SPRINGBROOK TRUNK SEWER
18" V.C.P. SEWER LINE & SIPHON FROM STRONG STREET TO HALE STREET ALONG SPRINGBROOK CHANNEL.

ADAPTED FROM PLAN S-197 BY RIVERSIDE ENGINEERING CO. & J.F. DAVIDSON TO SHOW EXTENT OF CITY CONTRACT.

5048
S-418
5-29-63
1 2

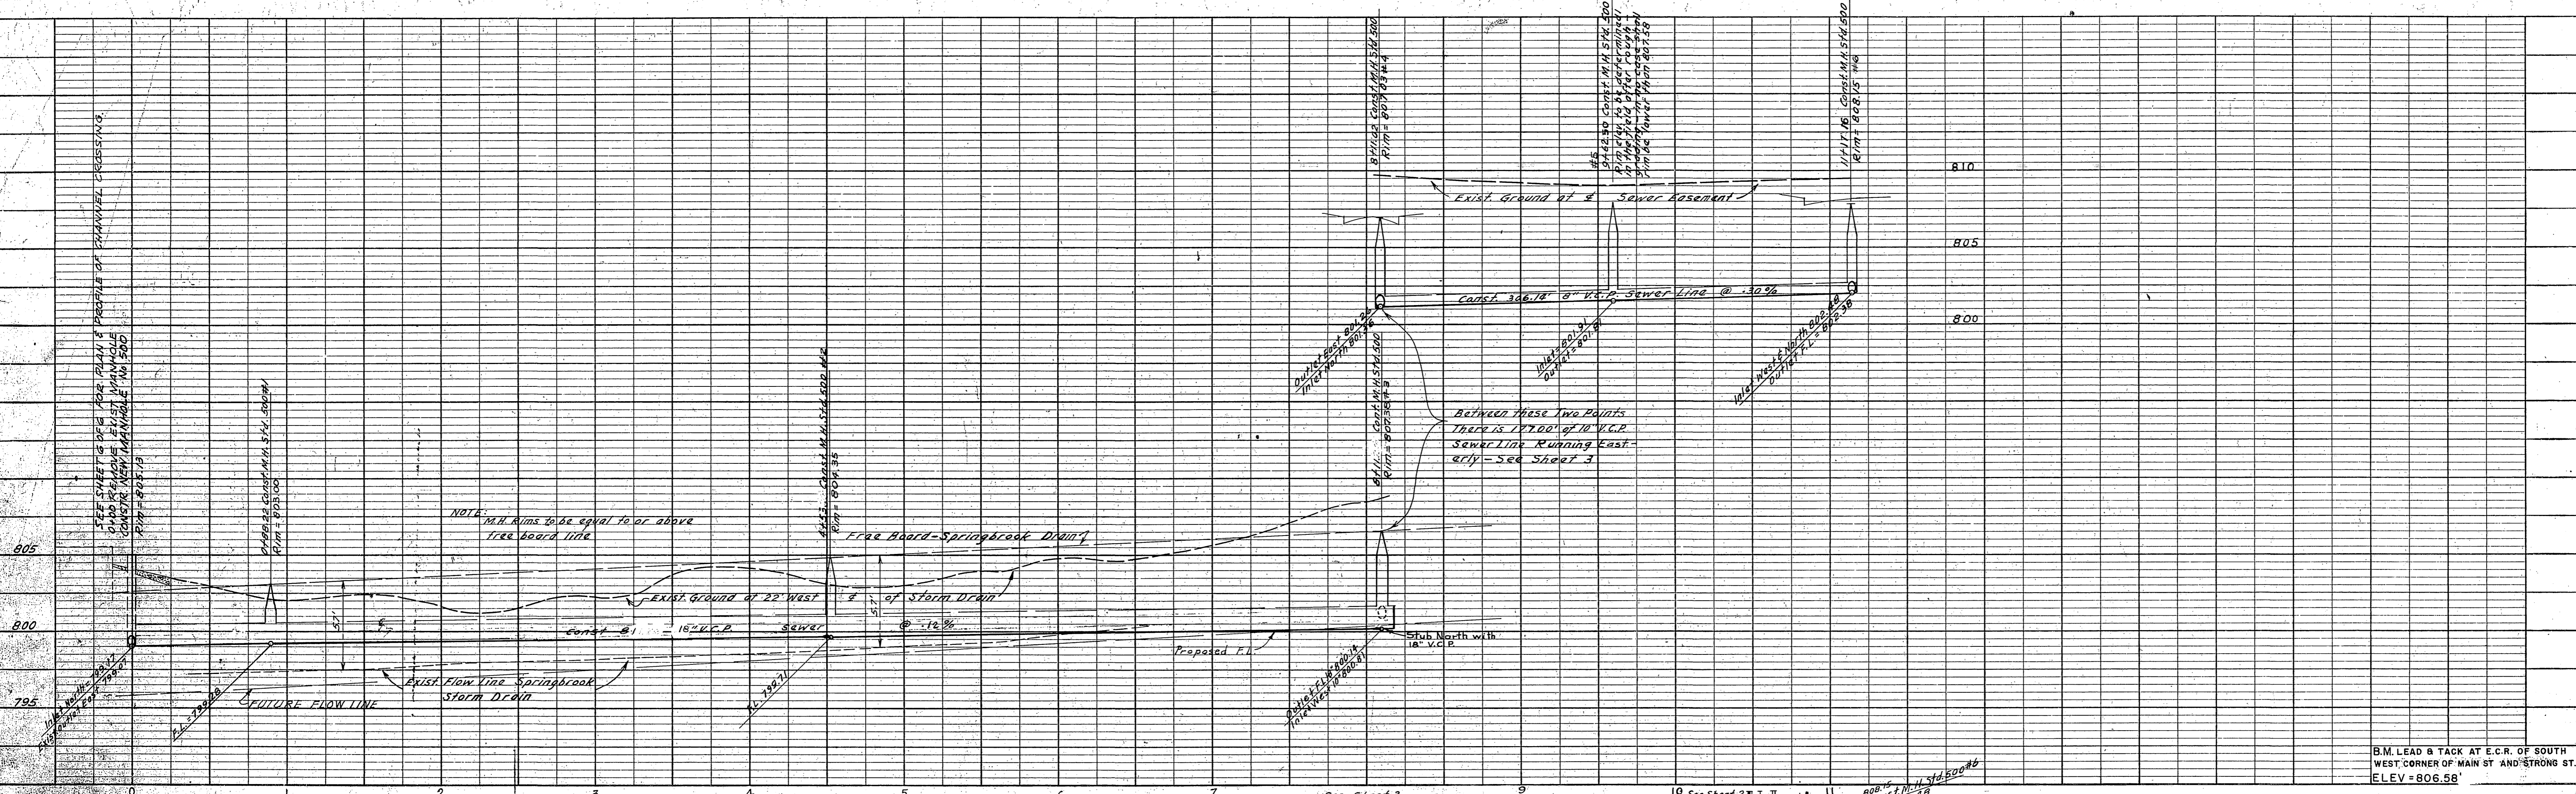
- ① 8-21-43. Revise alignment of sewer from 0+00 to 4+53.34 (see 1001) Approved: J.H. [Signature] Director of Public Works
- * 8-23-43. Add storm drain and lateral from N.R.T.
